JAMA Proposal for ELSA meeting, January 22, 2009**ELECTRICAL SAFETY PROVISIONS FOR VEHICLES IN USE**

Attached Sheet 1

ISOLATION RESISTANCE MEASUREMENT METHOD**1. General**

Figure 1: Measurement of V_b , V_1 , V_2

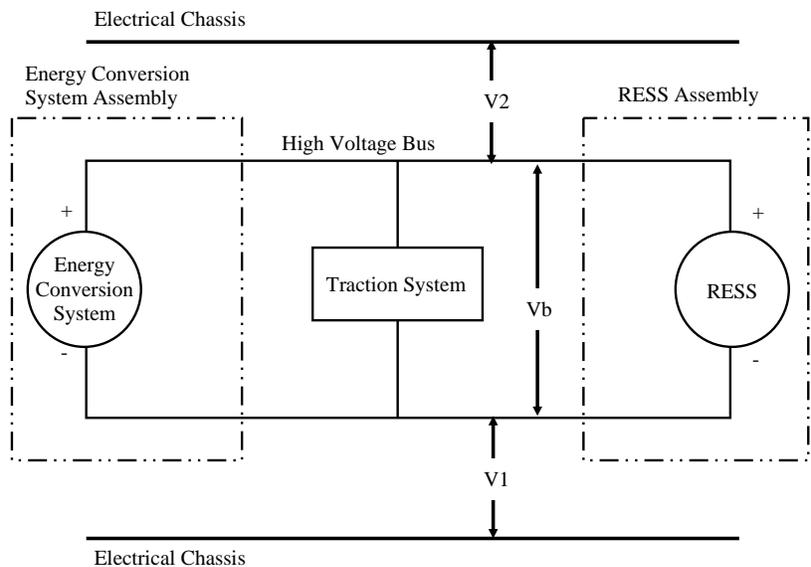
Comment [トヨタ自動車株式会社
ame as 2-2-1.

The voltage is measured as shown in Figure 1 and the high voltage Bus voltage (V_b) is recorded. V_b shall be equal to or greater than the nominal operating voltage of the RESS and/or energy conversion system as specified by the vehicle manufacturer.
